STAFF REPORT	
COMMUNITY DEVELOPMENT DEPARTMENT

HEARING DATE: July 11, 2023
 TO: Mayor & City Council
 FROM: Sonya Allen, Associate Planner
 208-884-5533
 SUBJECT: Julia Subdivision – AZ, PP
[H-2023-0003](#)
 LOCATION: 2435 N. Black Cat Rd., in the NE 1/4 of
 Section 4, T.3N., R.1W. (Parcel
 #S1204141840)

Annexation (AZ) of 2.77 acres of land with an R-8 zoning district; and preliminary plat (PP) consisting of 10 buildable lots and 5 common lots on 2.77 acres of land in the R-8 zoning district for Julia Subdivision.

B. Preliminary Plat (dated: 6/12/23)

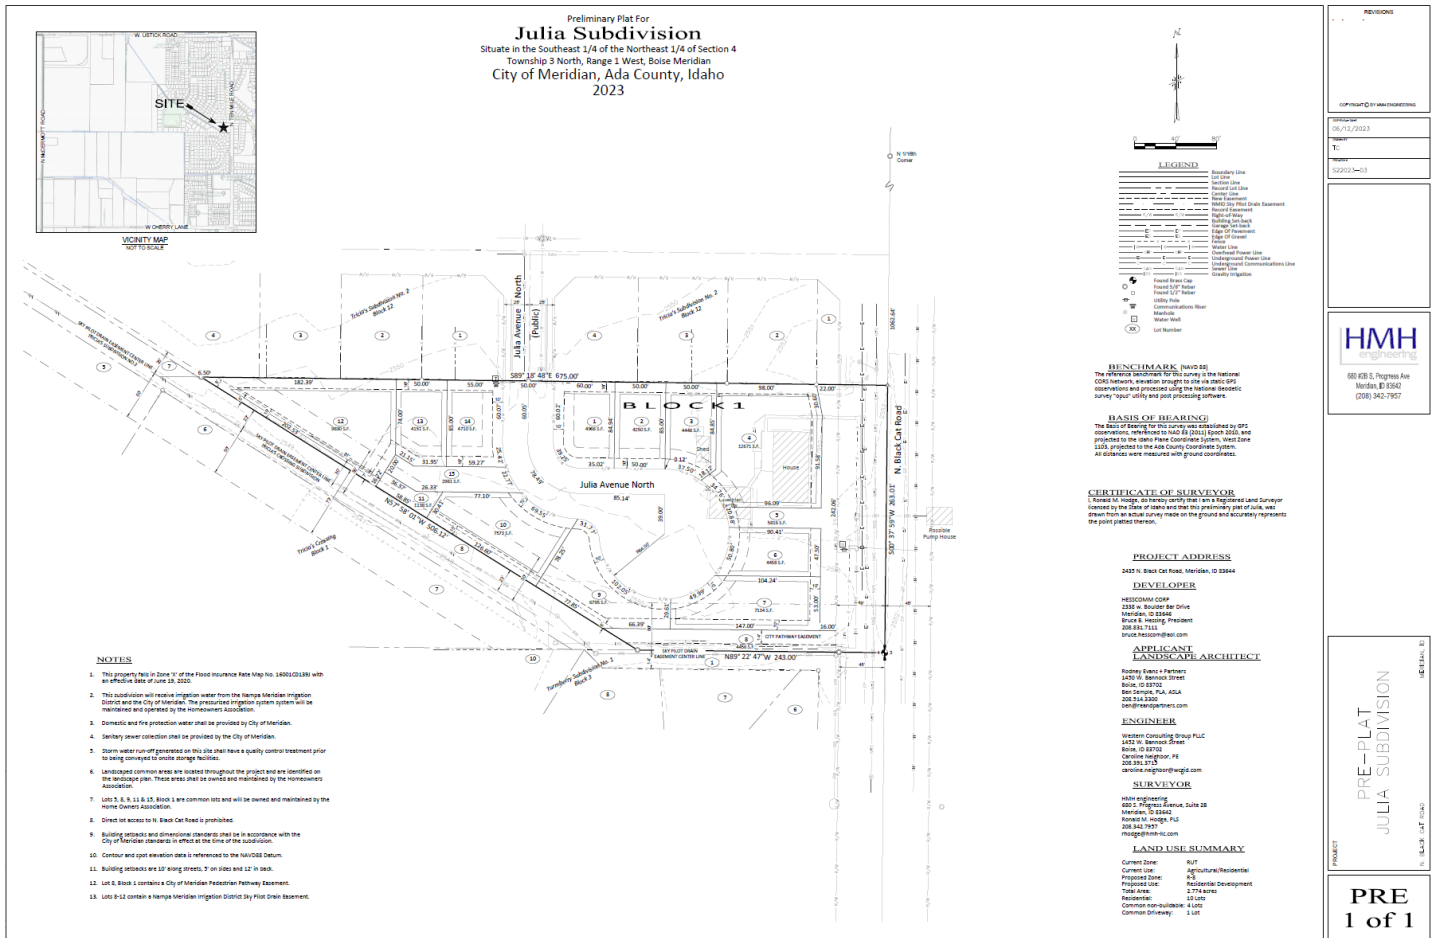
- d. Delete note #6. *These lots are identified in note #7.*
 - e. Modify note #9 as follows, “. . .in accord with the City of Meridian standards in effect at the time of ~~the subdivision~~ building permit submittal.”

- f. Delete note #11 pertaining to specific building setbacks.
 - g. Include the recorded instrument number of the public pedestrian easement on Lot 8 in note #12.

- h. Modify note #13 to include Lot 15 as it also contains the Sky Pilot Drain easement. Also, include information about the anticipated license agreement with NMID, including the recorded instrument number of the agreement, and the specifics of what is and isn’t allowed in the easement area.

- i. Depict the 50-foot wide easement for the Sky Pilot Drain, measured from the center line of the pipe, within a common lot outside of a fenced area, unless modified by City Council at a public hearing with notice to surrounding property owners as set forth in UDC [11-3A-6E](#). ***The Applicant requests Council approval for the easement to be located on building and common lots (i.e. Lots 7, 9-12 and 15) rather than a common lot.***

C. Common Driveway Exhibit

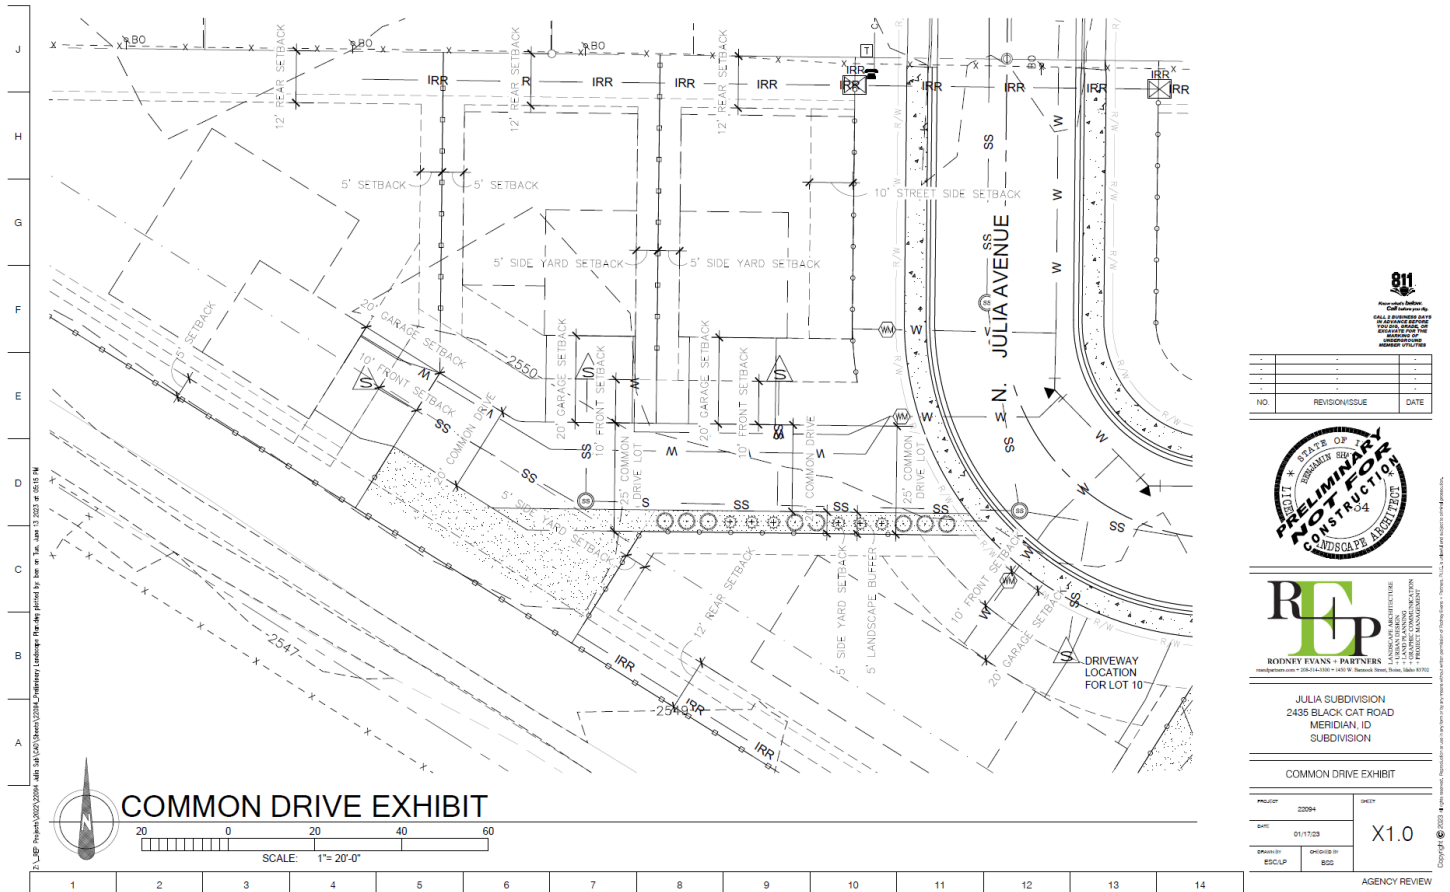
4. The common driveway on Lot 15 shall comply with the standards listed in UDC [11-6C-3D](#) and the exhibit in Section VIII.C.
5. A perpetual ingress/egress easement shall be filed with the Ada County Recorder, which shall include a requirement for maintenance of a paved surface capable of supporting fire vehicles and equipment. A copy of such should be submitted with the final plat for City Engineer signature. *Alternatively, a note could be included on the plat per condition #2c above.*

D. Landscape Plan (dated: 6/13/2023)

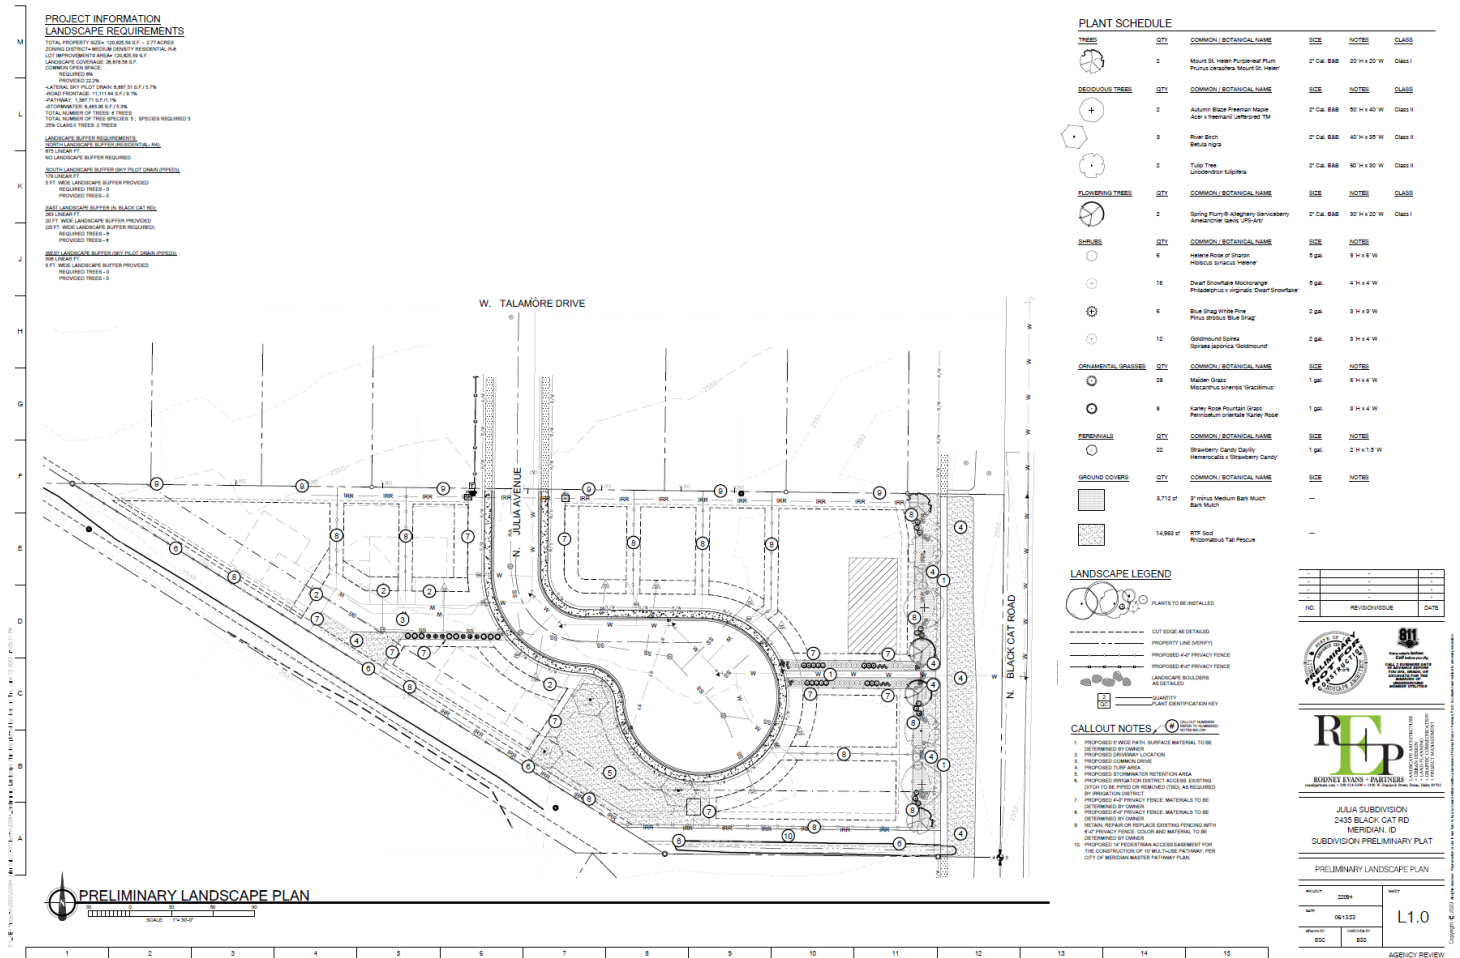
3. The landscape plan submitted with the final plat shall include the following revisions:
- a. Depict a minimum 25-foot wide street buffer along N. Black Cat Rd., measured from the ultimate curb location as anticipated by ACHD; depict the future curb location as anticipated by ACHD.

- b. Include mitigation information for all existing trees being removed from the site in accord with the standards listed in UDC [11-3B-10C.5](#).
 - c. Depict a 10-foot wide detached sidewalk/multi-use pathway within the street buffer along N. Black Cat Rd.

- d. Depict landscaping along each side of all pathways in accord with the standards listed in UDC [11-3B-12C](#). *Note: If NMID will not allow trees within the easement for the Sky Pilot Drain adjacent to the multi-use pathway, alternative compliance may be requested to this standard.*

- e. Change the fencing type along the western boundary of the site adjacent to the common open space in Tricia’s Crossing subdivision to open vision or semi-private up to 6-feet in height or if closed vision fencing is proposed, it can’t exceed 4-feet in height, as set forth in UDC [11-3A-7A.7b](#).

- f. Depict the 50-foot wide easement for the Sky Pilot Drain, measured from the center line of the pipe, within a common lot outside of a fenced area, unless modified by City Council at a public hearing with notice to surrounding property owners as set forth in UDC 11-3A-6E. ***The Applicant requests Council approval for the easement to be located on building and common lots (i.e. Lots 7, 9-12 and 15) rather than a common lot.***
